RECONSULTATION REVIEW OF ADDITIONAL INFORMATION

LBHGEO have been previously commissioned to provide an independent assessment of the Basement Impact Assessment (BIA) information submitted for this application. (Ref: HGY/2023/0850)

This document provides a response to a 14 day re-consultation issued by the Haringey Development Management Team on 17th April 2024 to allow review of additional information submitted.

Extract of Fig 5-3 of January 2022 Section 19 Flood Investigation report (McCloy Consulting)

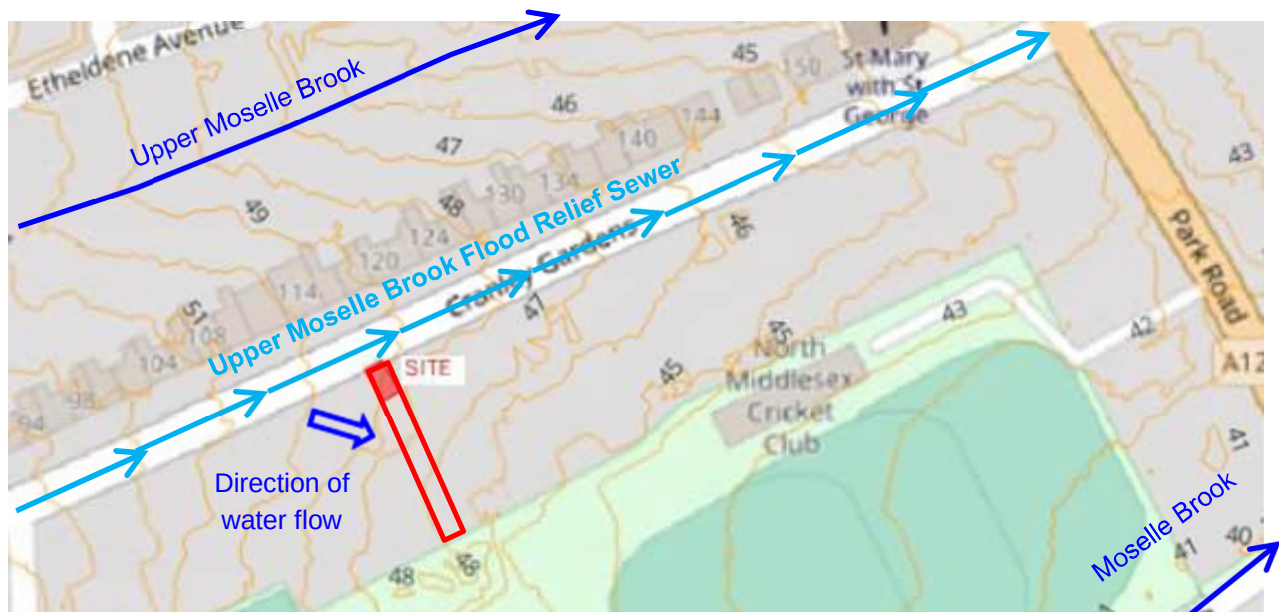
On issue 4.7 there is a misinterpretation of a figure the January 2022 Section 19 Flood Investigation Report for Park Road (North) by McCloy (reproduced below) and a suggestion that the Moselle Brook flowed along Cranley Gardens itself and had been culverted. This misinterpretation of the Upper Moselle Brook Flood Relief sewer flood seems to have given rise to concern by the BIA auditors about possible soft and water-bearing alluvial deposits.

A cursory inspection of the topography of Cranley Gardens show that Cranley Gardens runs down an elevated spur that forms a watershed between two streams and it is a reflection of the quality and extent of the applicant's flood risk assessment that this has not been recognised.

Annotated extract of Fig 4 of Flood Risk Assessment and SuDS report (Symmetrys)

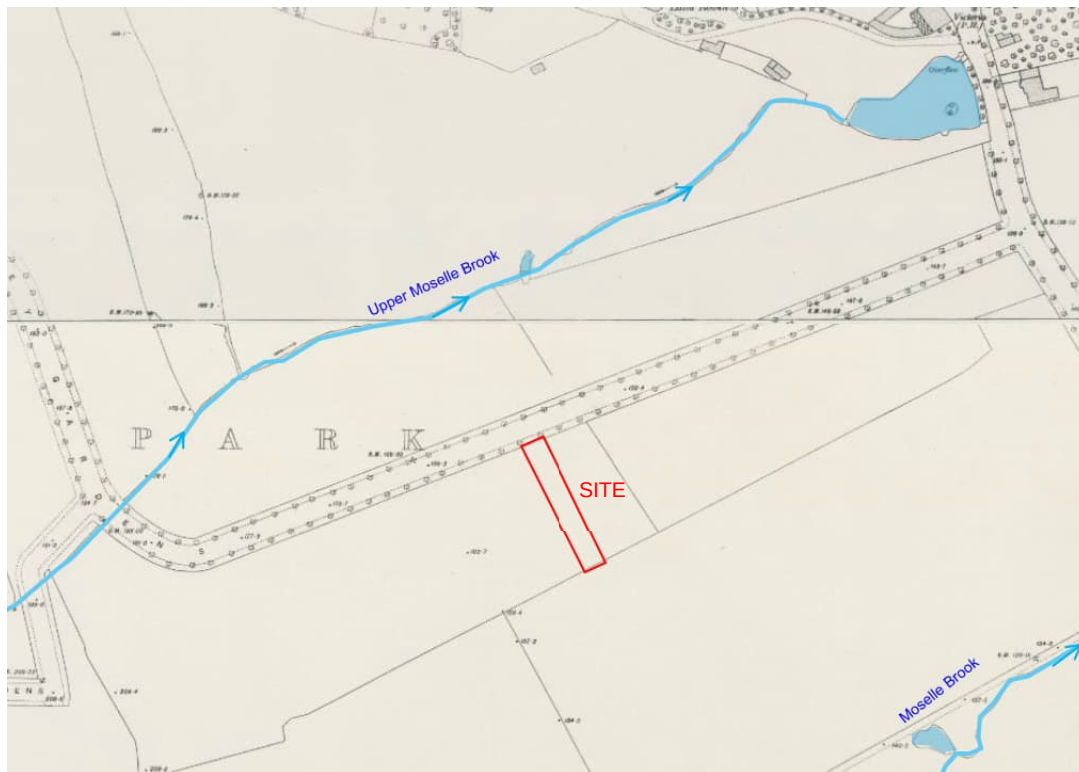
Instead the applicant introduces a proposal to introduce **“ground improvement across the site”** and recommends **“trial pits to be dug across the site and logged by a geotechnical engineer prior to any construction works.”** These proposals suggest an apparent general lack of understanding of the ground at this site.

6.3 | Swimming Pool and Mezzanine Gym from Pool

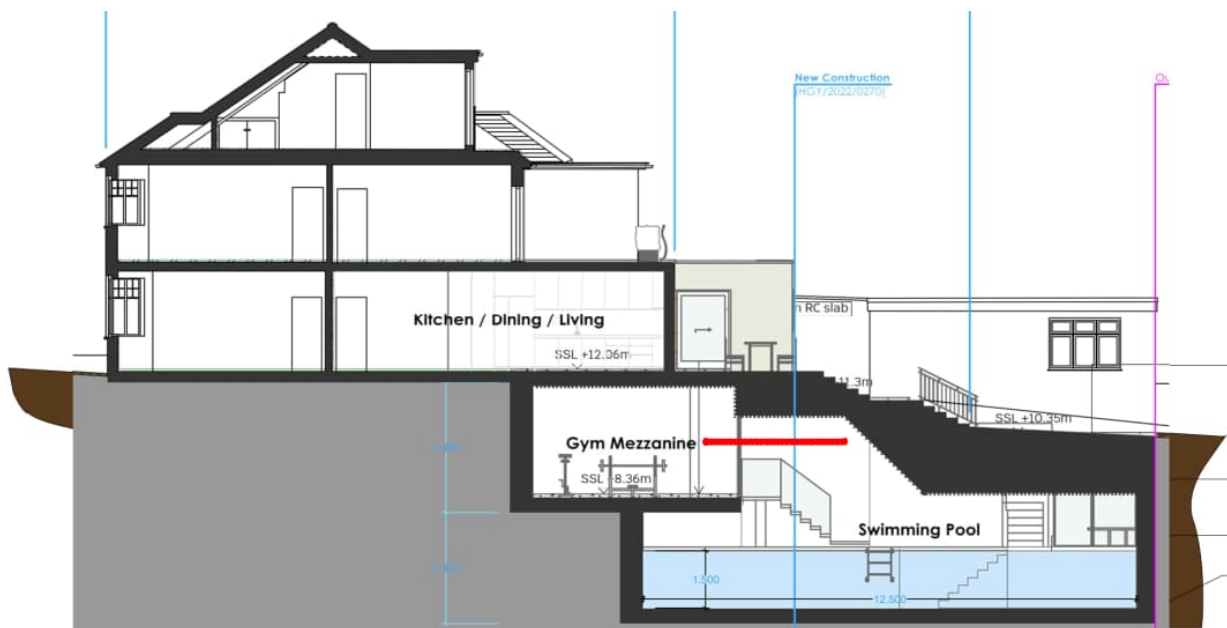
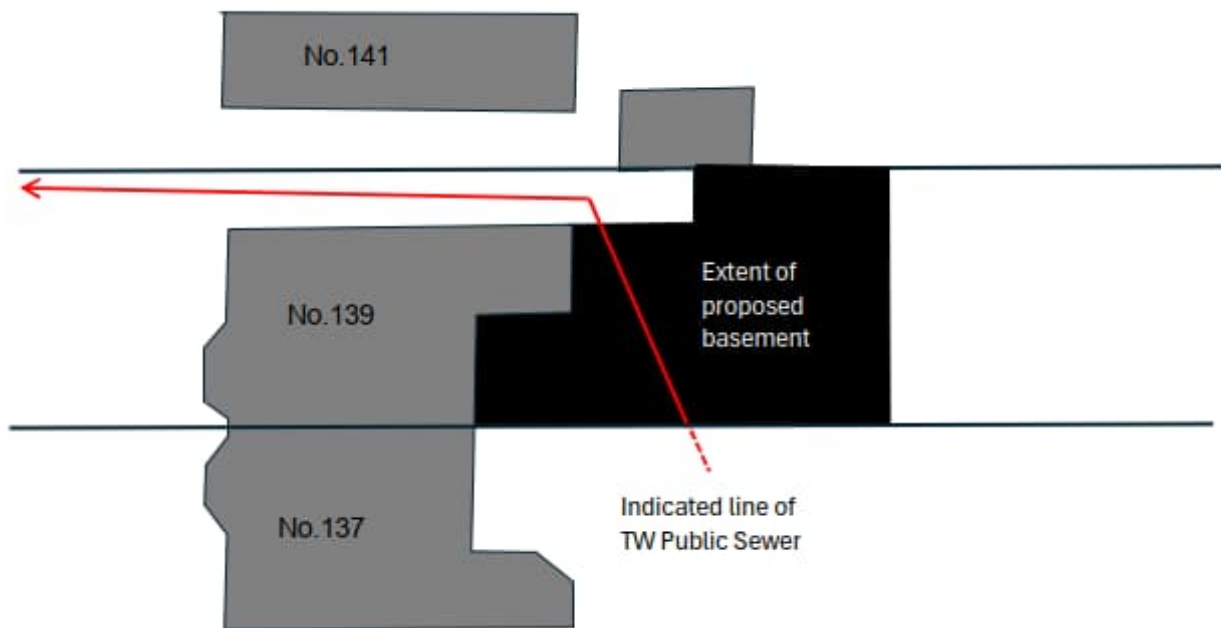
To illustrate more clearly the clash with the public sewer, we have annotated the images provided in the submitted Design & Access statement to show approximately what the development would look like if the existing public drain were simply to be retained as is currently being proposed by the applicant.

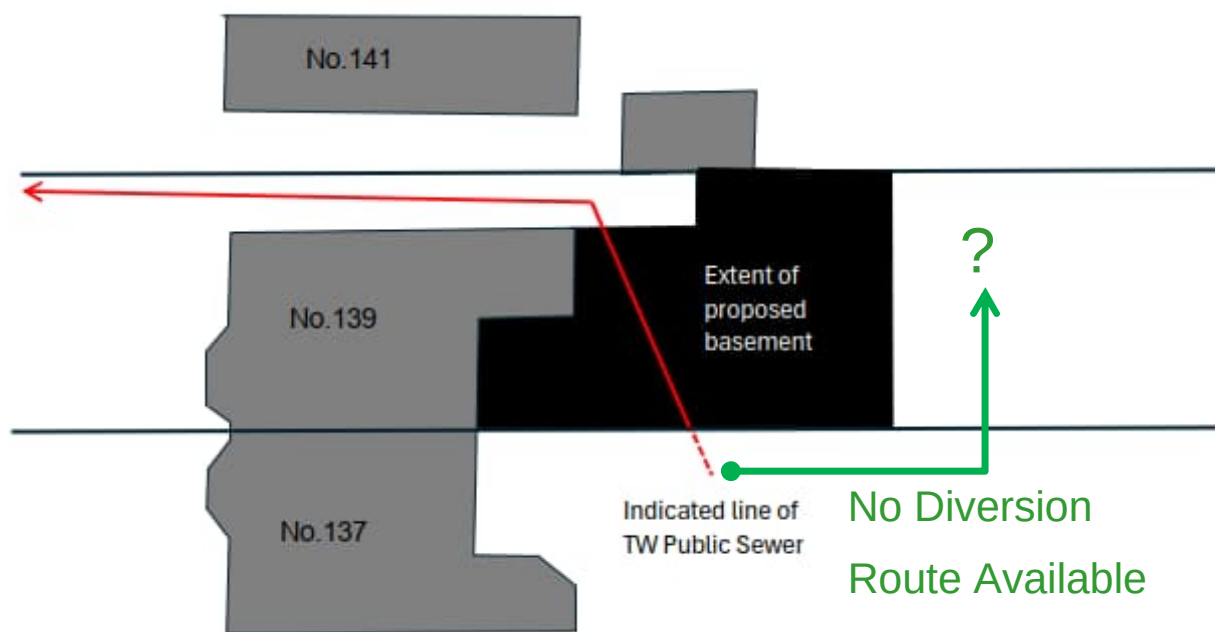
The red pipe is an existing 100mm vitrified clay shared public combined drain that is the responsibility of Thames Water to maintain.

It is patently clear from the above images, plans and sections (which were not presented to Thames Water) that the present drain will need to be abandoned and diverted. It is also immediately clear from the plan above showing the extent of the proposed basement that there is no potential alternative route for the drain to follow if the proposed development is permitted.

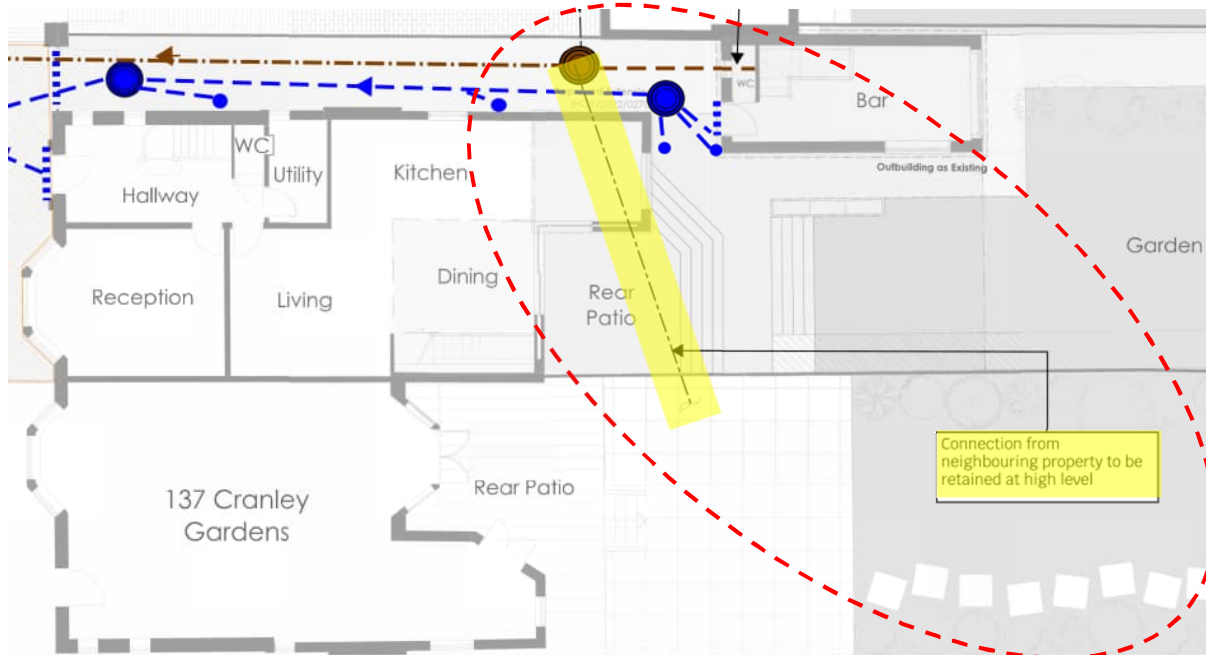
From a technical perspective it is obviously necessary for any new drainage route to:

- maintain the required gradient for gravity flow.
- be accessible for Thames Water to maintain and repair.

As neither of these approaches will be possible the proposed development would appear to be **unbuildable**.
